I would like to thank the reviewers for their thoughtful comments on the manuscript and the authors for their efforts in addressing those comments resulting in improvements in clarity of the described approach and analysis. I am pleased to preliminarily accept the manuscript for publication, but would ask that the authors address a few additional minor points I include below.

Editor comments on revised manuscript:

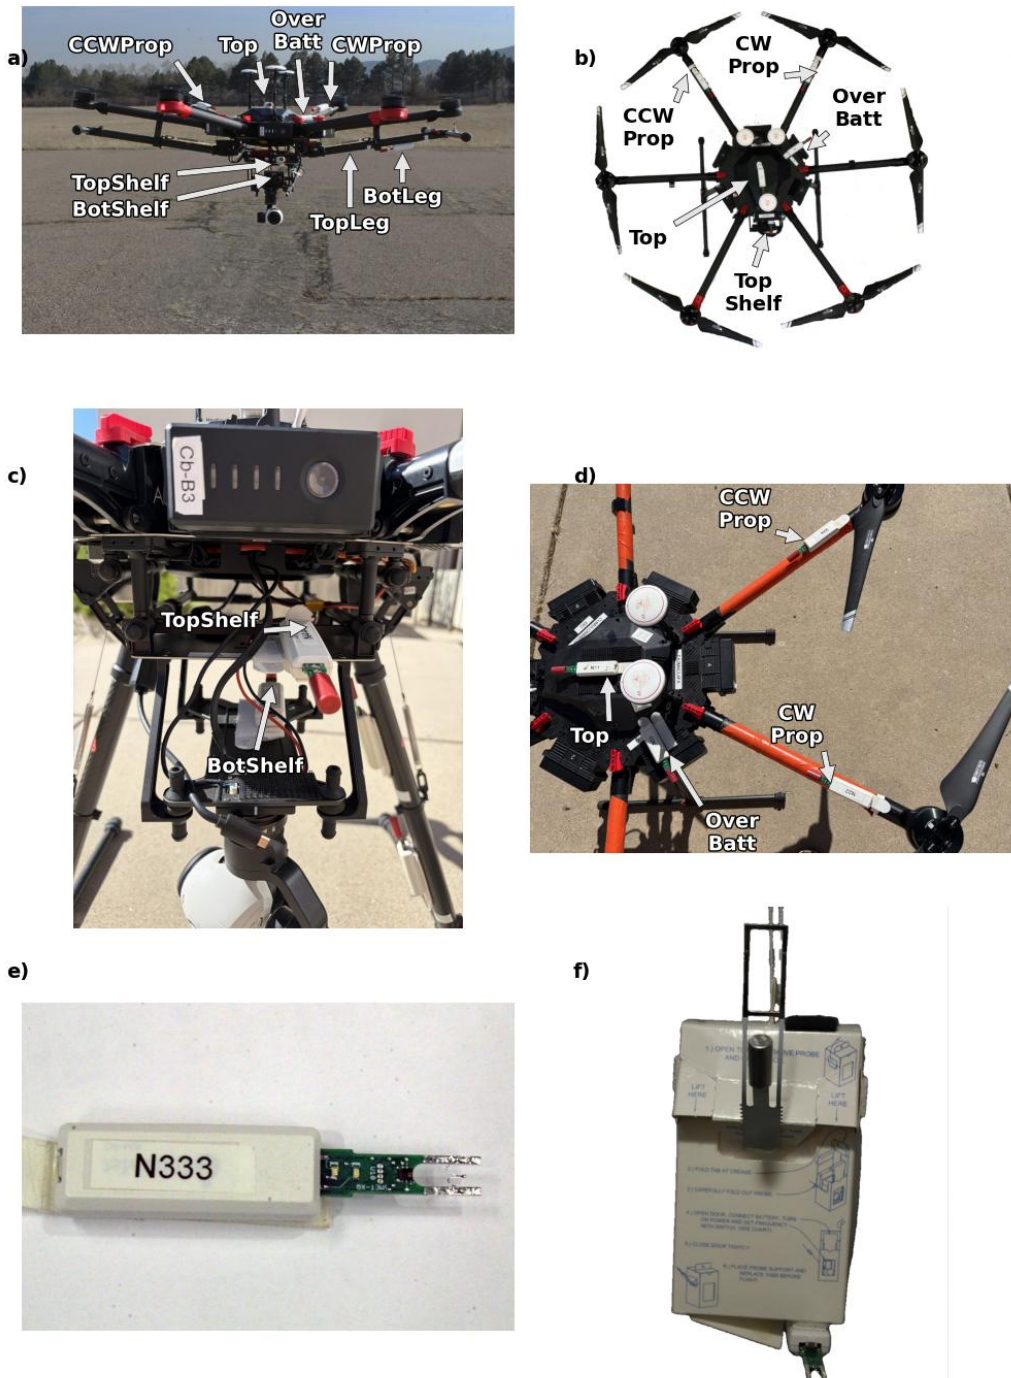
Fig1: check CW and CCW labels

L91: in “b)”, “the positions” or “locations”

Thanks very much for catching these errors. We have resolved this in the figure and caption in the manuscript, and have put the new figure and caption below.

Figure 4: As in Figure 3a, except that for each sensor position, the tethersonde data is stratified by solar radiation, E ($W m^{-2}$), observed by the surface weather station.

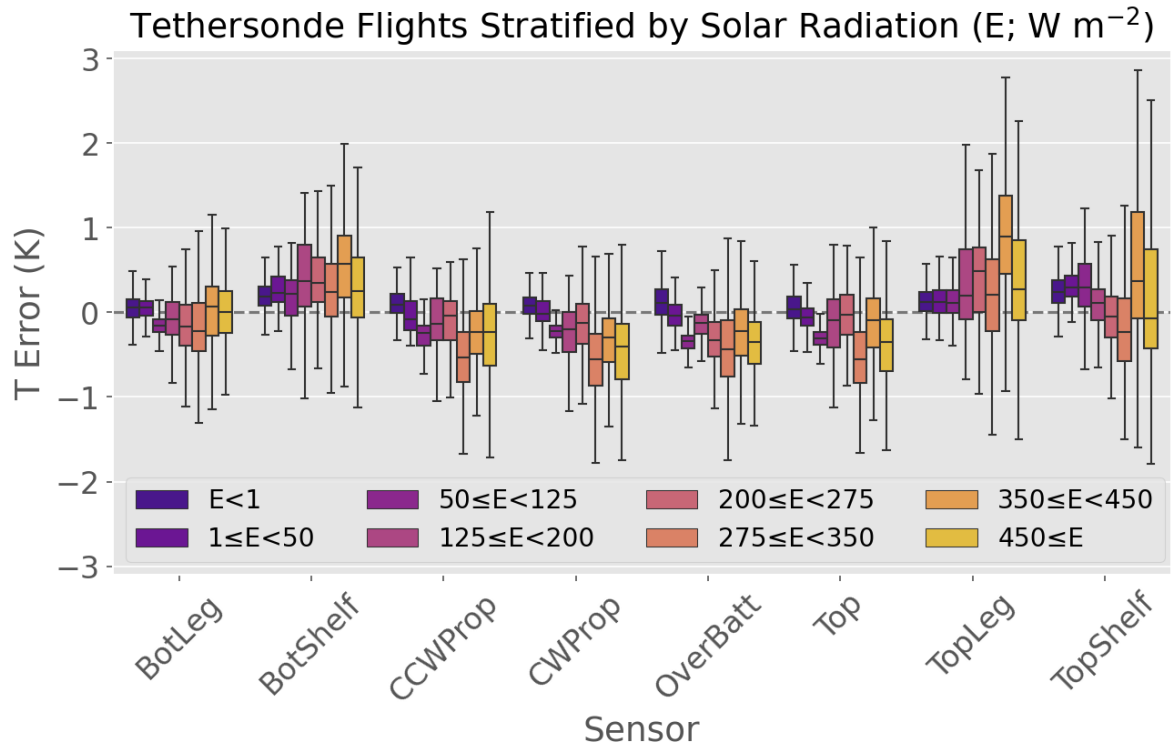
Fig4: suggest adjusting x-axis labeling for readability (also Fig7)

We have rotated the x-axis labels on both of these figures for readability. We have reproduced these figures below.

Figure 7: As in Figure 4, but for water vapor mixing ratio errors.

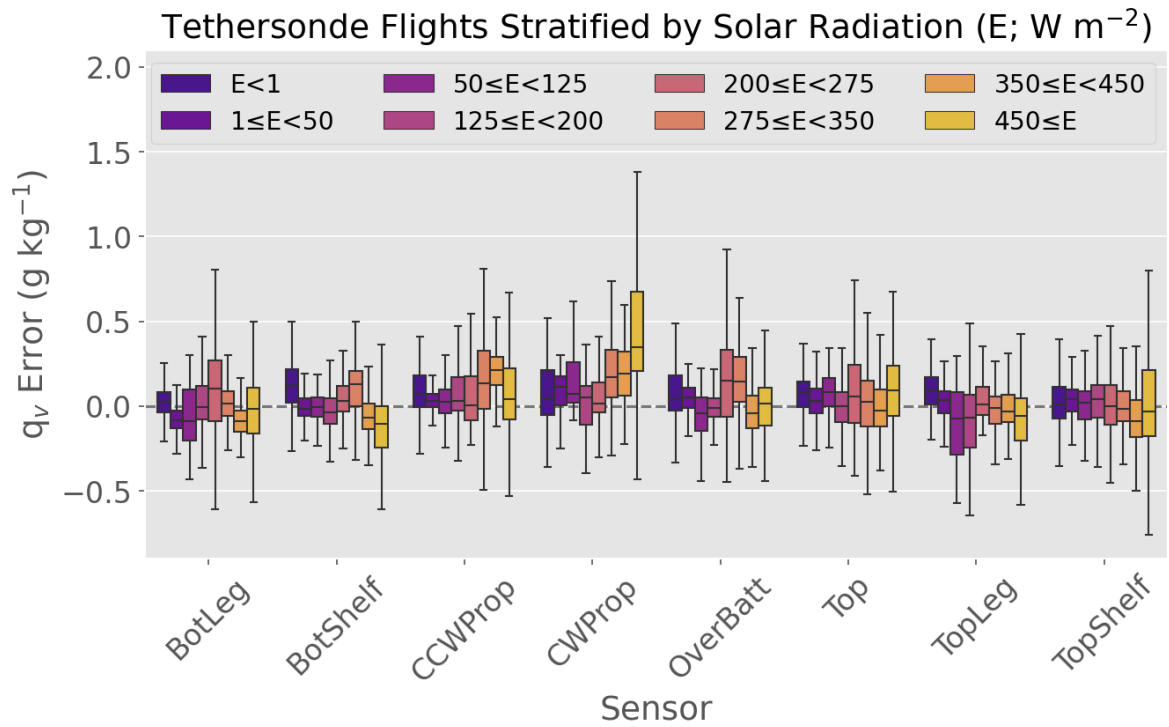
L375: the statement about the trends in mean and std dev of q with insolation in Fig 7 seem to be a stretch. Did you do any analysis (e.g. regression) that would show significance? Did you contact the sensor manufacturer about the relative time response speculation on line 380? Did you try to look at the error as a function of ΔT magnitude and direction?

We have revised this language to be much less conclusive, as the signal is not very strong.

We have removed the speculation about response time. While the manufacturer does note a different RH response time from temperature response time on the sensor used, the difference is not substantial.

“The 82 tethered flights are stratified by solar radiation (Figure 7), as in Section 3a for temperature, to determine the contribution of solar radiation to the water vapor mixing ratio error. This figure shows that, for some positions (e.g., CWProp, CCWProp), the errors (spread and mean bias) in water vapor mixing ratio increase with increasing solar radiation. However, this signal is unclear for other positions (e.g., BotShelf, BotLeg), and there are even trends that stay approximately constant for some positions (e.g., TopShelf). The mean biases for all positions are less variable than the standard deviations, however. The changes in standard deviation with varying solar radiation suggest that there is a contribution of radiative error to the total water vapor mixing ratio error. This is despite the fact that the RH sensor measures the temperature that the RH is based on and this temperature is used in the calculation of the water vapor mixing ratio. However, it is impossible to conclusively determine the exact cause of the radiative error with the data collected. Future work should explore this issue further.” (lines 376-384)
